BL417 Geological Sciences Phase 2 F100 IGWS East
(F100) Lab Renovations
IU 20250361

ADDENDUM NO. 3
14217

Addendum #3

RE: Indiana University
BL417 GEOLOGICAL
SCIENCES - FACULTY
100 - GEOLOGICAL
SCIENCES

SECOND FLOOR NORTH
 HVAC DEMOLITION
 PLANS
H102

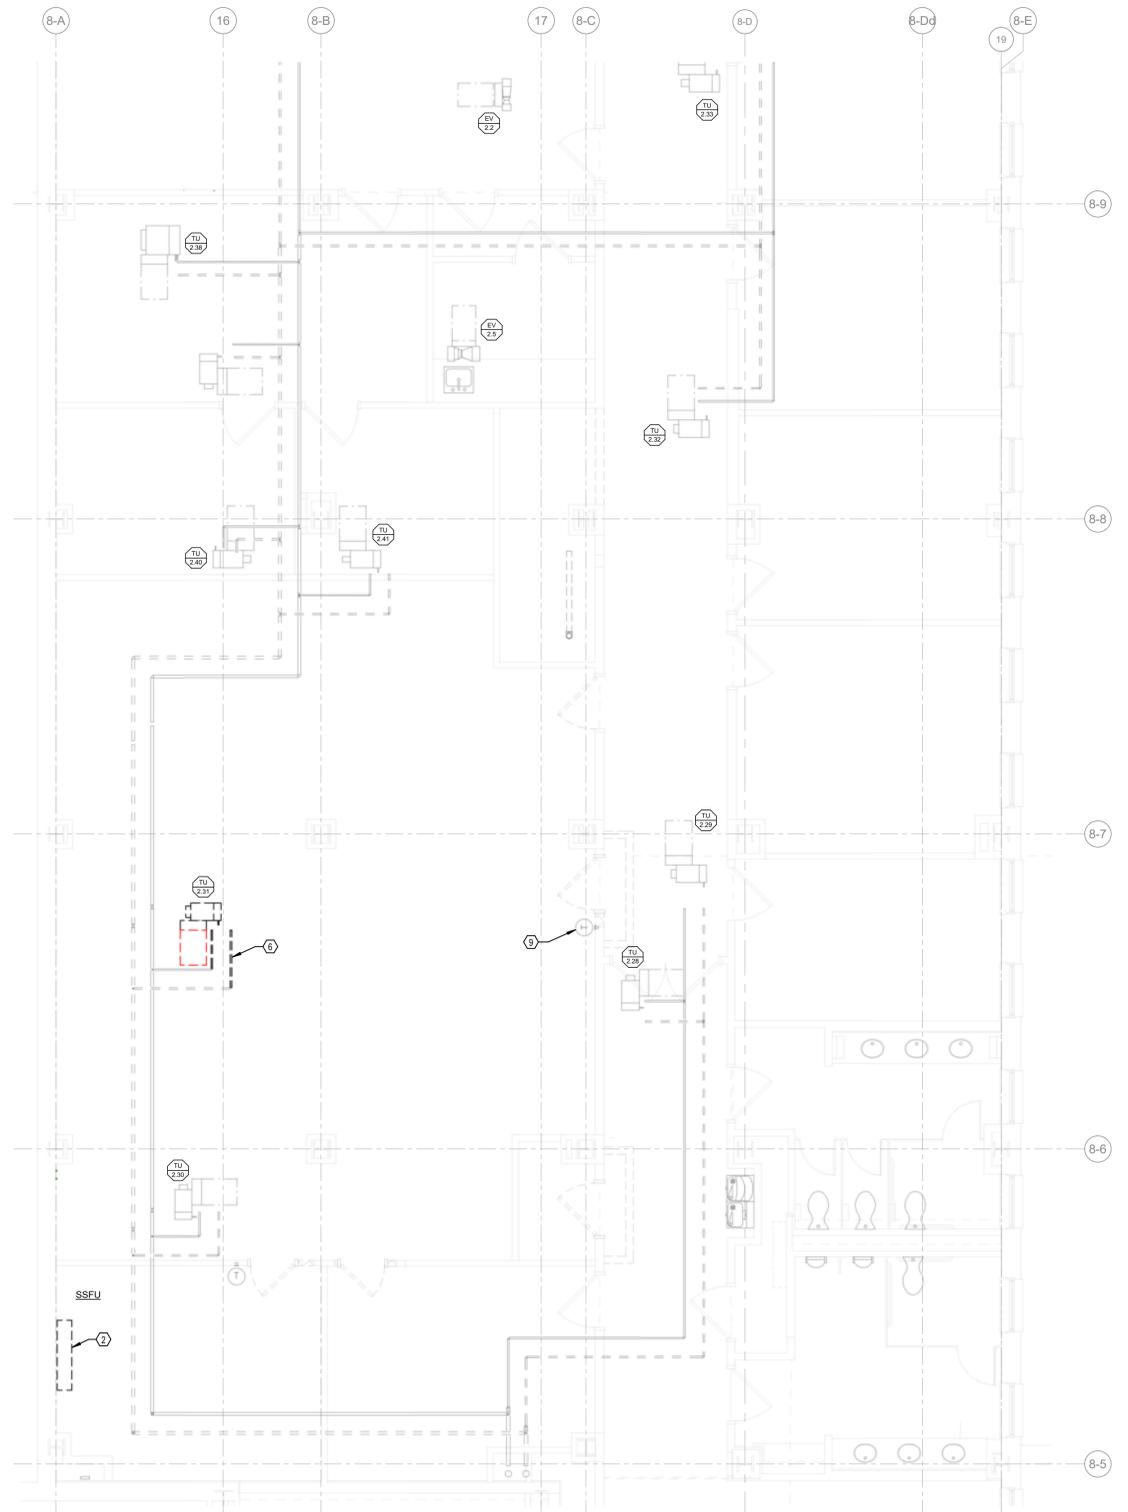
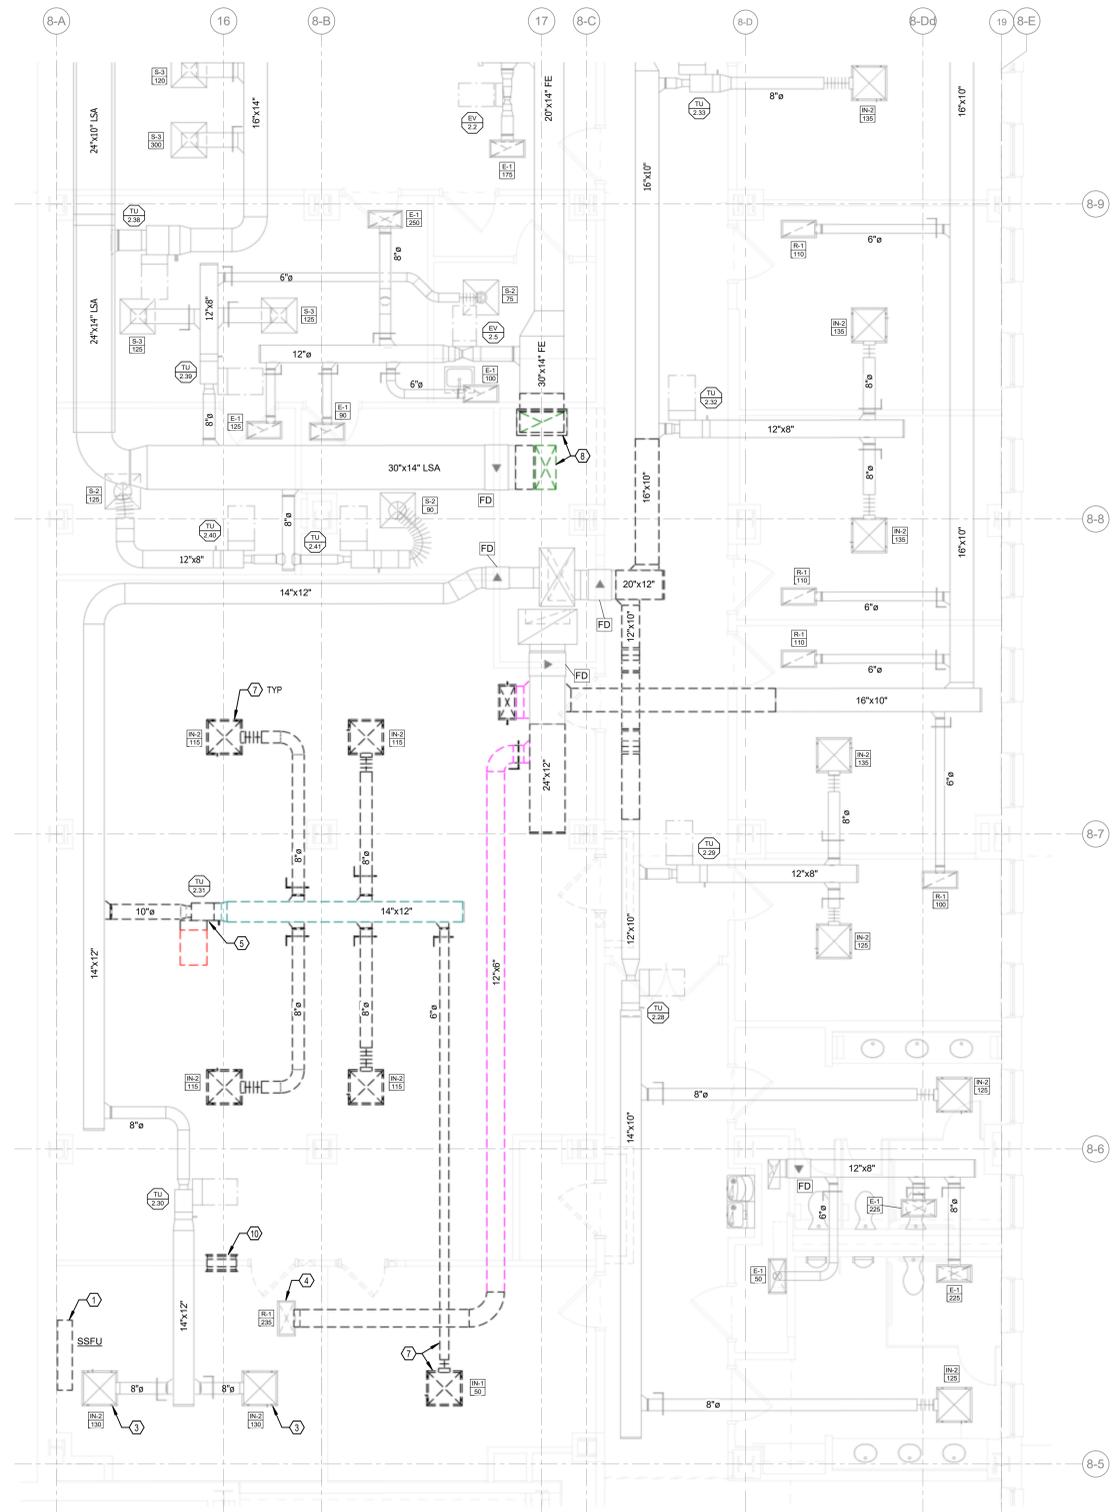
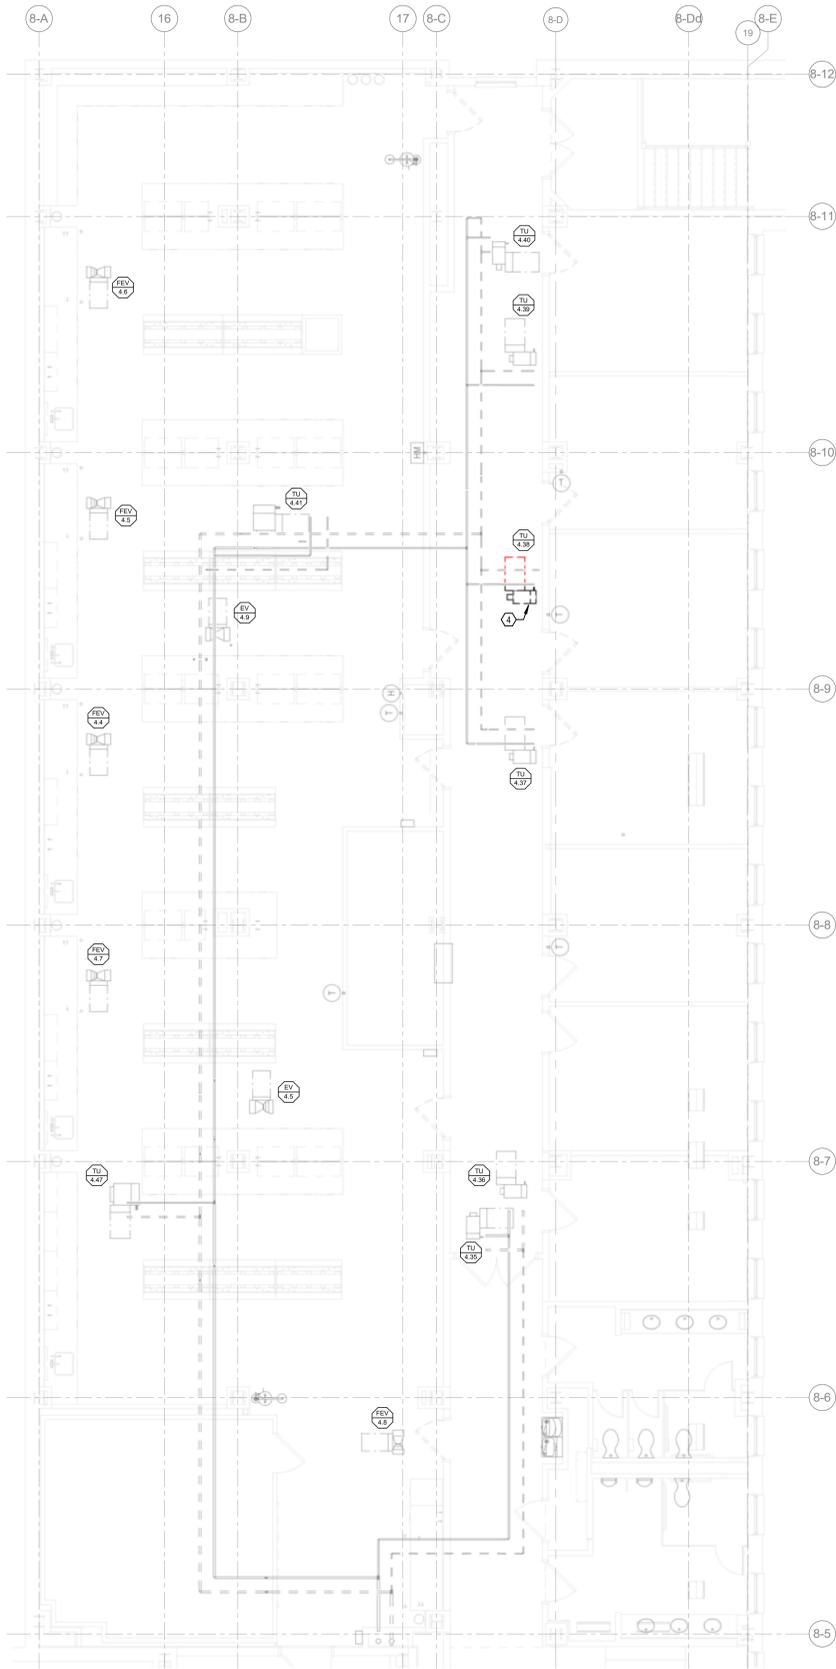
3. Sheets H102, 104, 104 – HVAC FLOOR PLANS
 - a. Clarified notes on VAV box piping and valve removal. See note above.
4. Sheet H201 – FIRST FLOOR HVAC PLANS

- 4 EXISTING RETURN GRILLE TO REMAIN. BALANCE TO NEW AIRFLOW SHOWN.
- 5 REMOVE VAV BOX AND UPSTREAM BRANCH DUCT COMPLETE. SAVE FOR REINSTALLATION.
- 6 REMOVE EXISTING HOT WATER PIPING CONNECTIONS TO EXISTING VAV BOX TO BE REMOVED OR RELOCATED. PREPARE FOR CONNECTION TO NEW VAV BOX. EXISTING VALVE PACKAGES MAY REMAIN. RELOCATE EXISTING HOT WATER TEMPERATURE CONTROL VALVE WITH THE BOX TO ITS NEW LOCATION - COORDINATE WITH SIEMENS.

FIRST FLOOR
NORTH HVAC
PLANS
H201

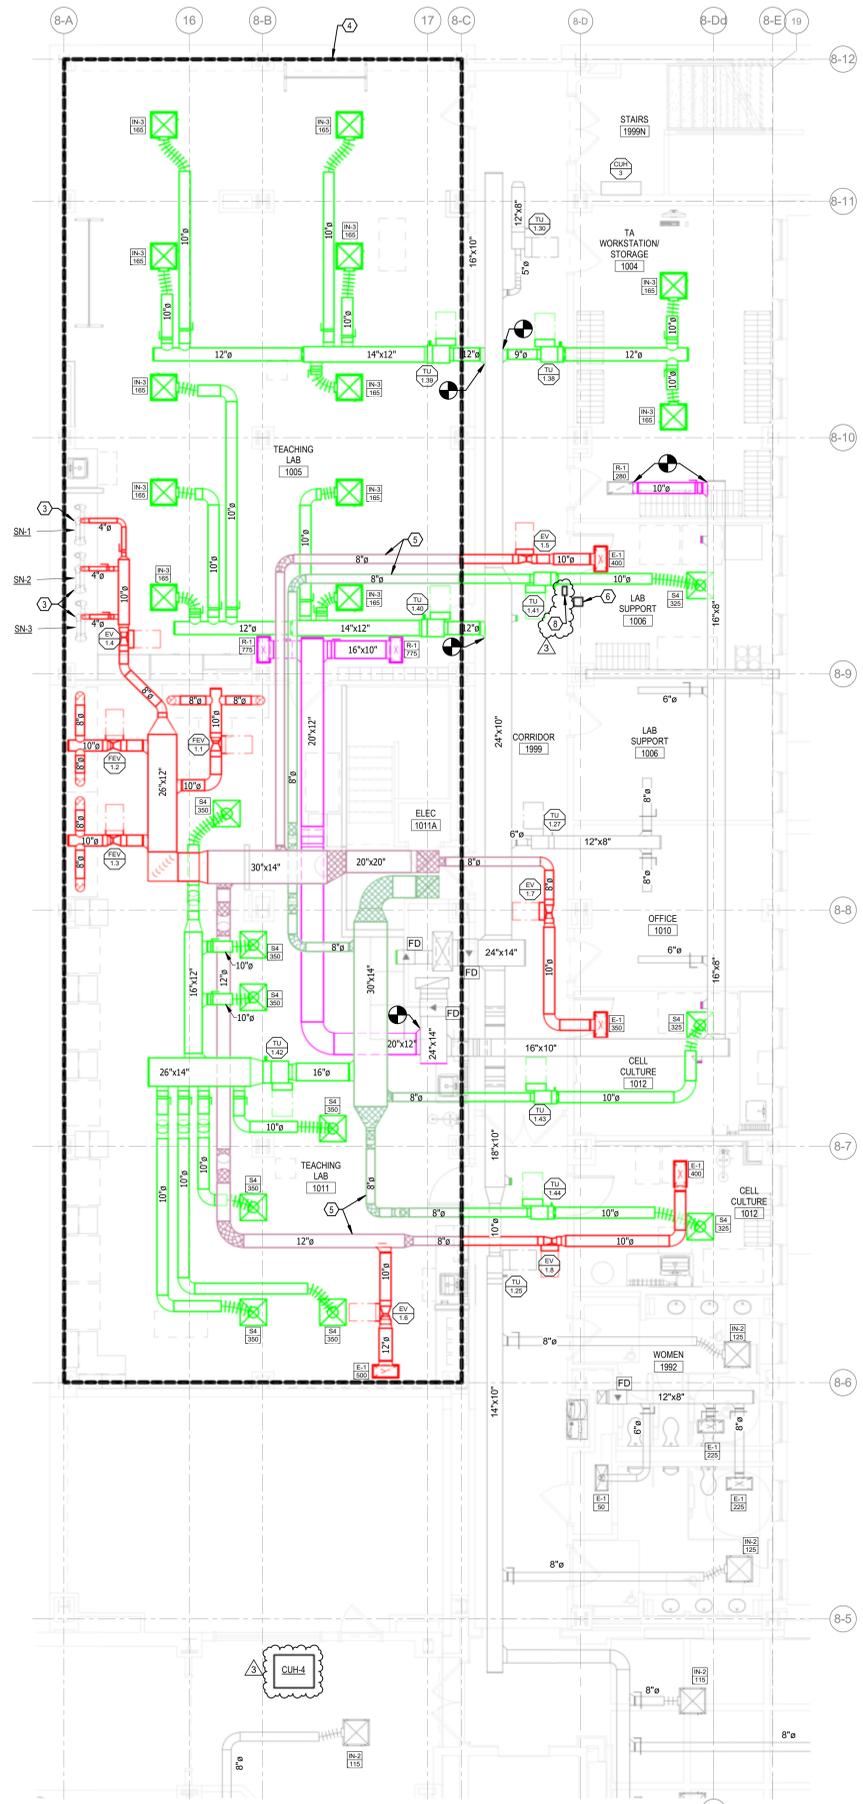
- a. Added remote alarm for oxygen sensor in Lab Support 1006.
 - b. Added cabinet unit heater CUH-4 in dock area.
 - c. Cleaned up plan notes.
5. Sheet H901 – HVAC SCHEDULES

- 6. REMOTE ALARM FOR OXYGEN SENSOR IN ROOM 1006. PROVIDE SIGN AT ALARM THAT STATES "OXYGEN DEFICIENCY ALARM. DO NOT ENTER ROOM WHEN ACTIVATED."
